Subject: FW: WBLR phase 3 – A2300 drainage approach

Subject: WBLR phase 3 – A2300 drainage approach

Subject: WBLR phase 3 – A2300 footway discharge rates

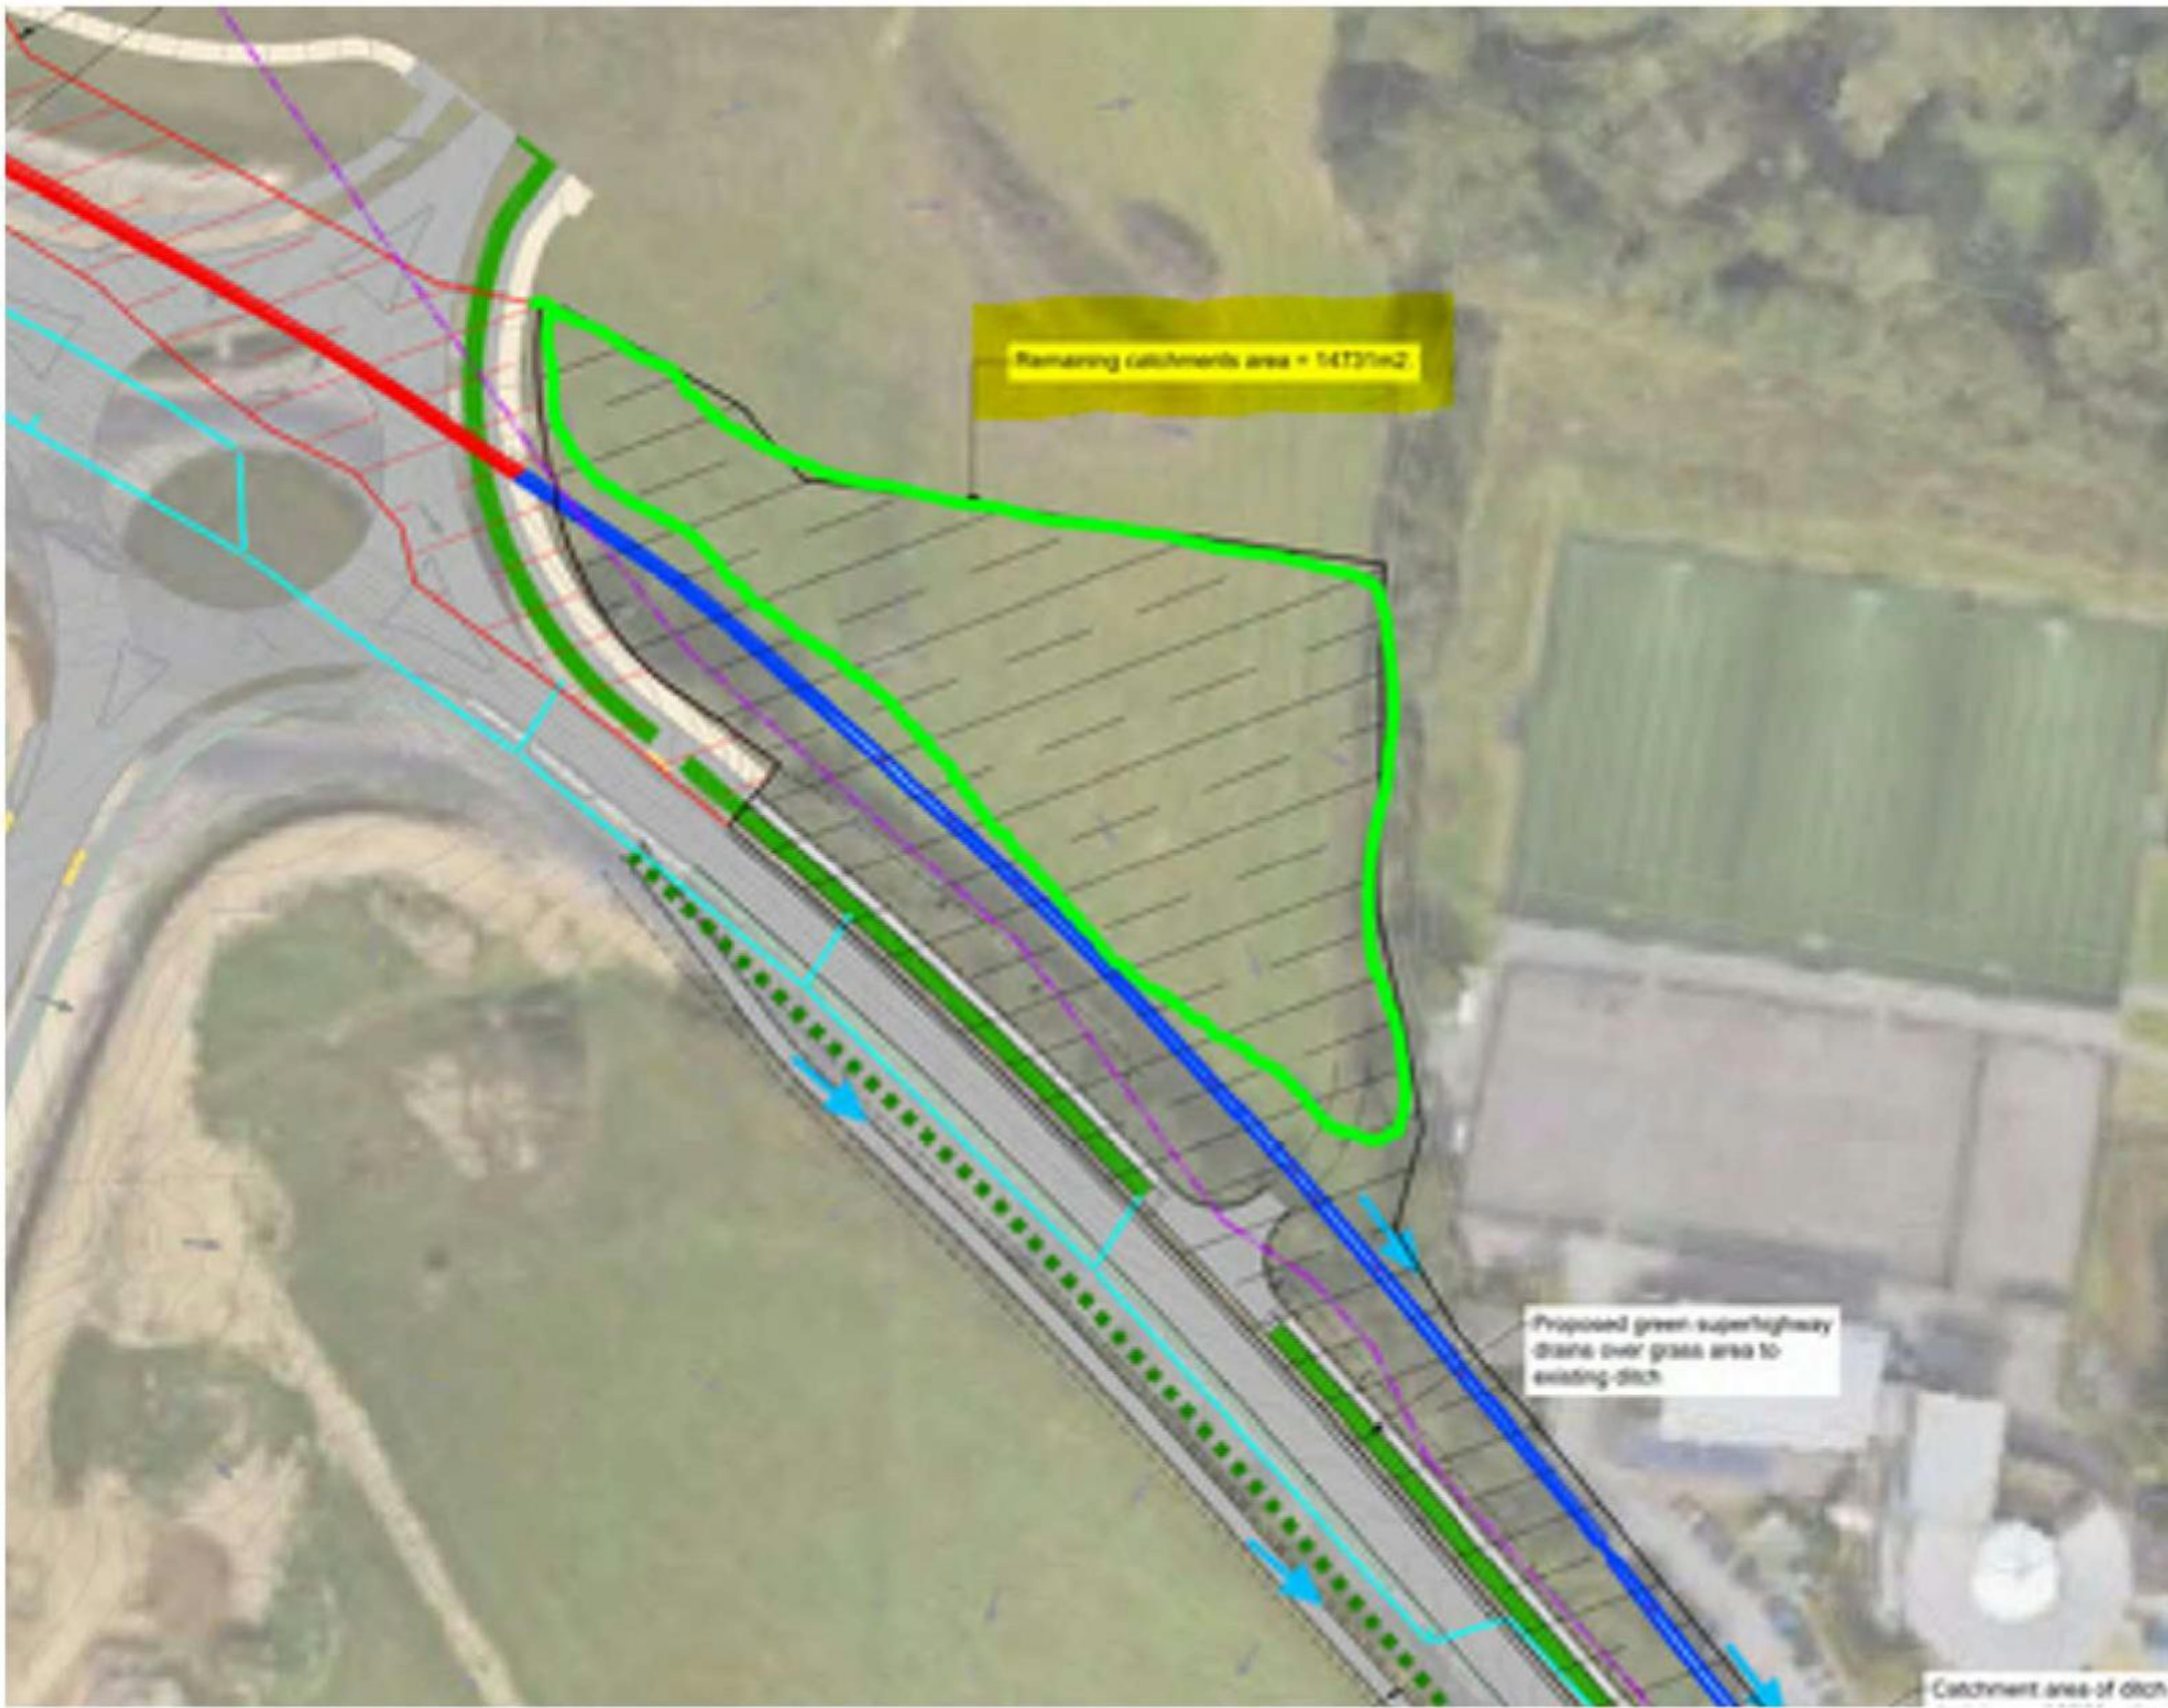
Also – another point regarding the flows into the existing ditch system that *might* have some bearing: The existing catchment includes an area of the adjacent field / development plot – approx. extent encircled in green below. When the plot is developed - a large portion of this area will then be drained to the north towards the River Adur and discharged at a controlled rate based on Qbar? We believe the plot development will not be allowed to discharge into the ditch at all - as it is a highway ditch in highway land? When this occurs – the flows in the ditch and then through the A2300 culvert will be further reduced such that they are then significantly lower than the greenfield / pre-development flows:

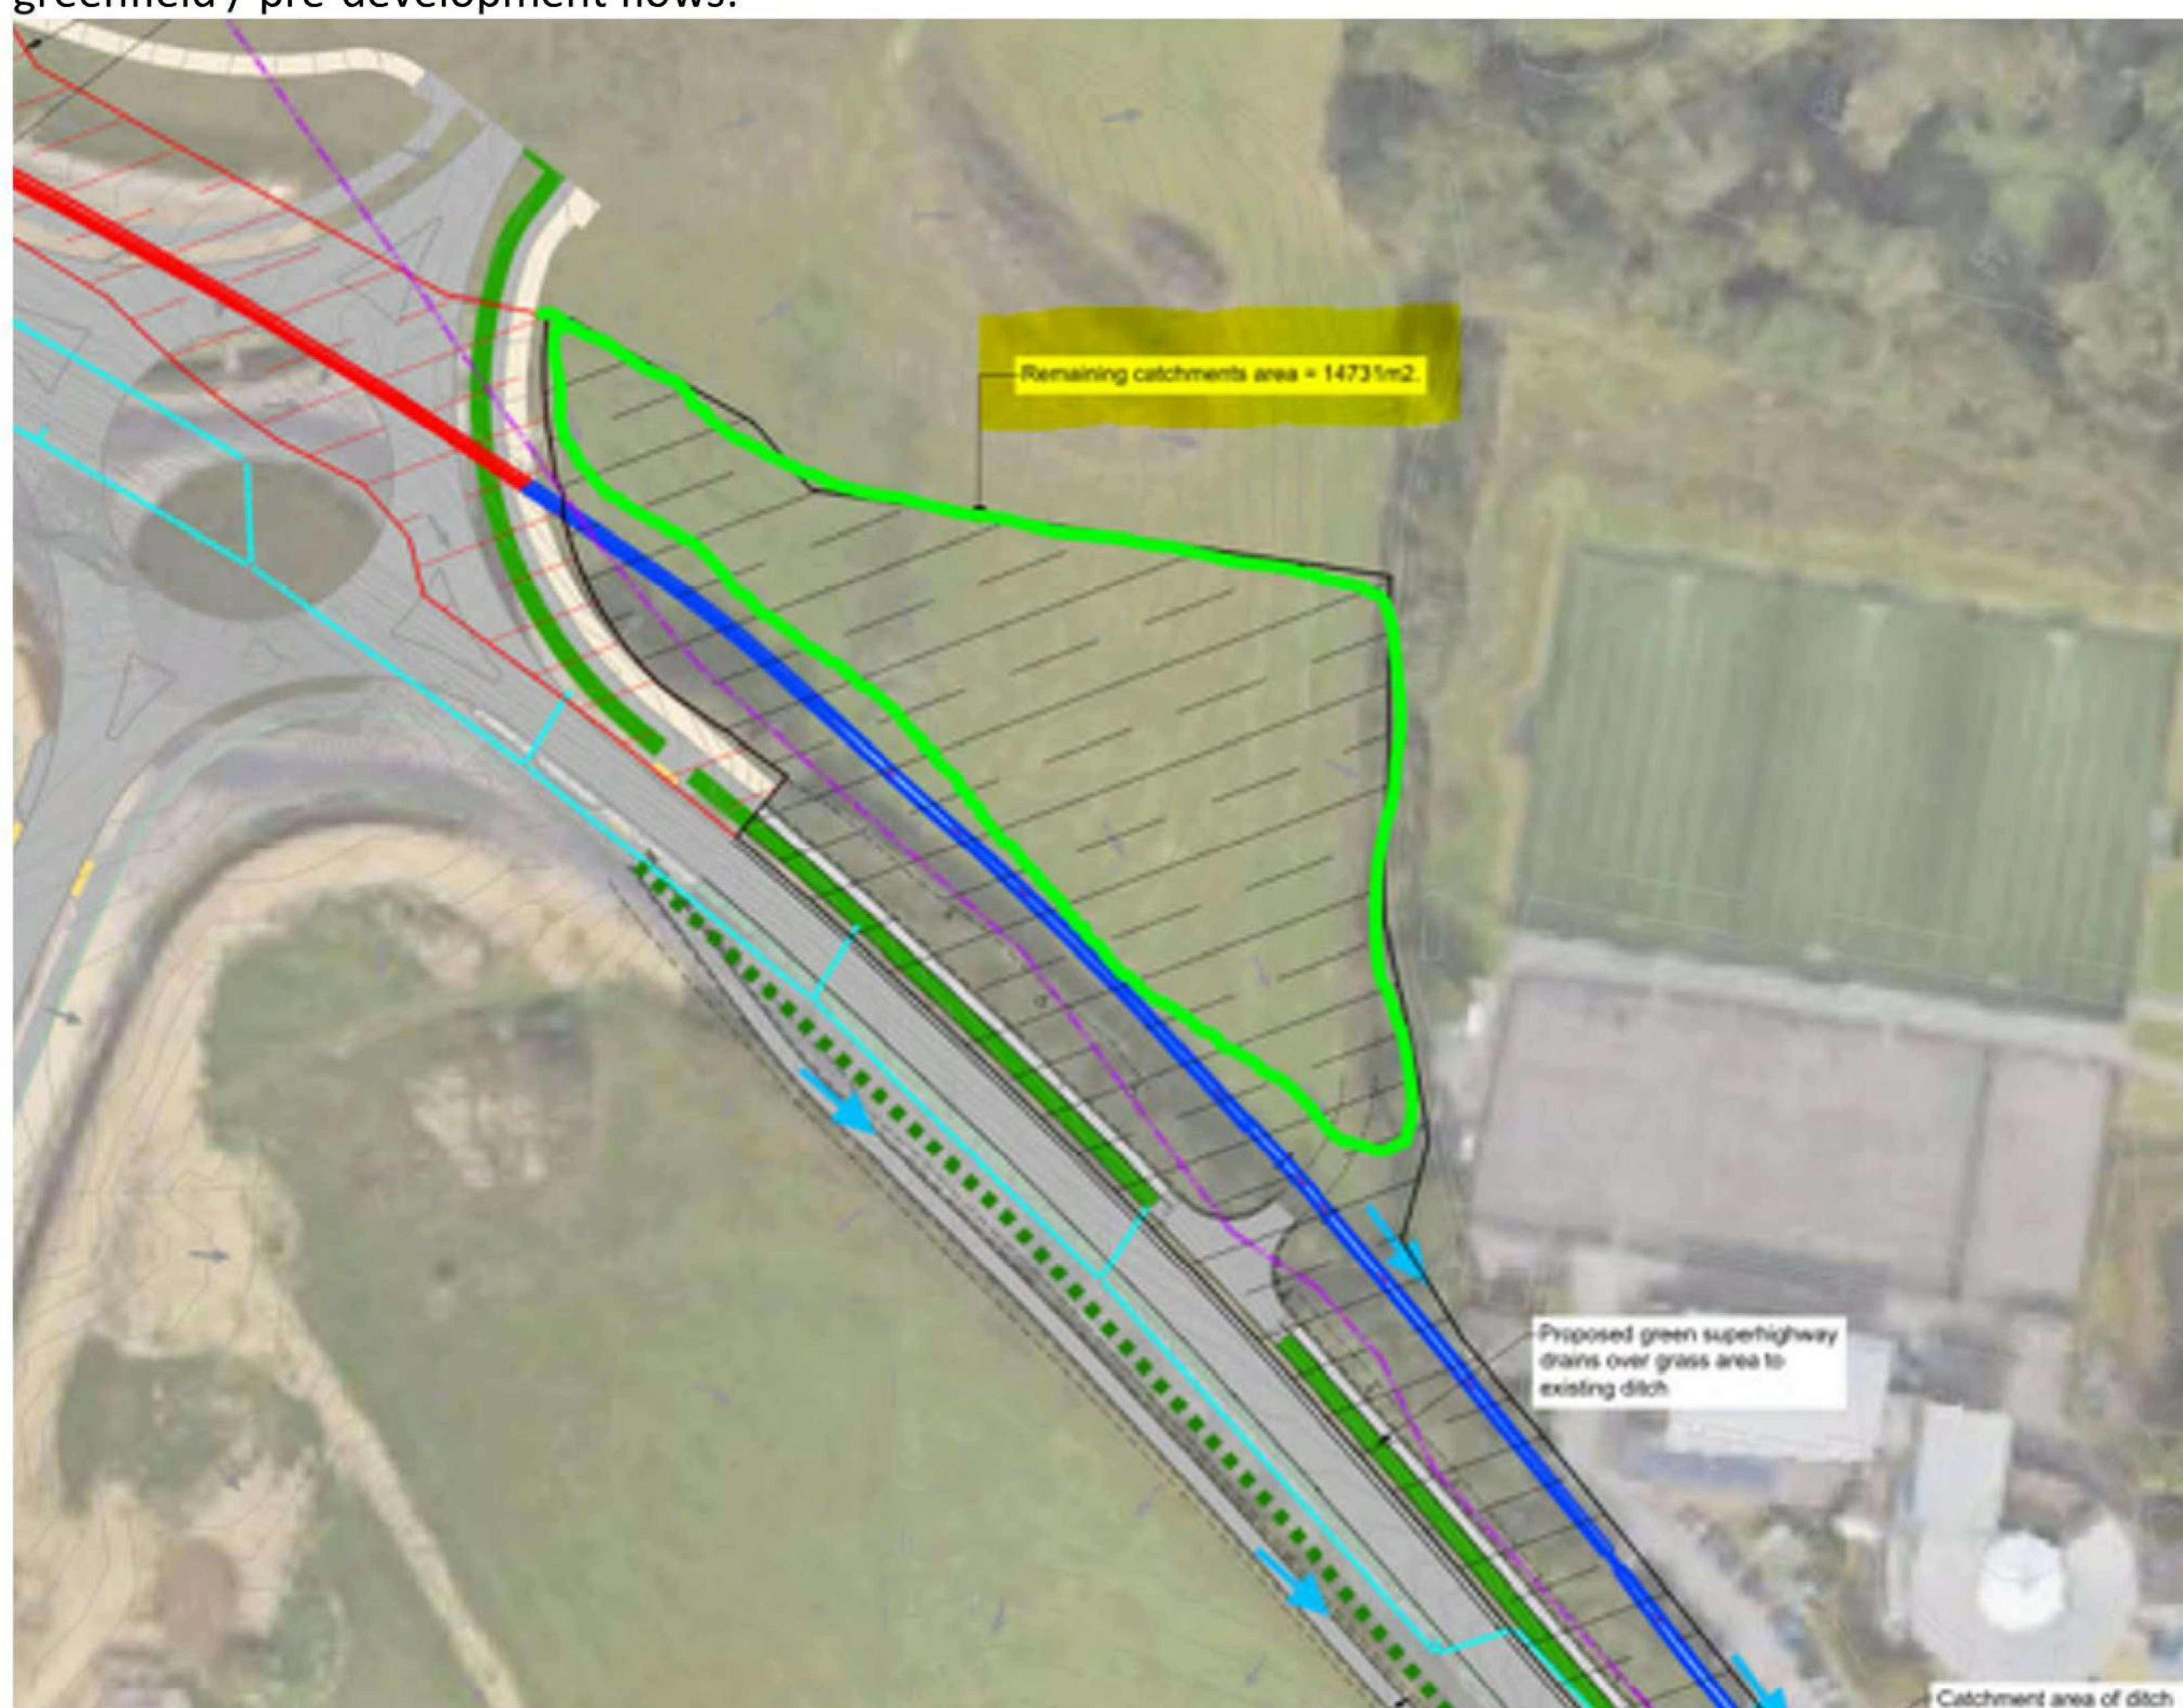
Also – another point regarding the flows into the existing ditch system that *might* have some bearing: The existing catchment includes an area of the adjacent field / development plot – approx. extent encircled in green below. When the plot is developed - a large portion of this area will then be drained to the north towards the River Adur and discharged at a controlled rate based on Qbar? We believe the plot development will not be allowed to discharge into the ditch at all - as it is a highway ditch in highway land? When this occurs – the flows in the ditch and then through the A2300 culvert will be further reduced such that they are then significantly lower than the greenfield / pre-development flows:
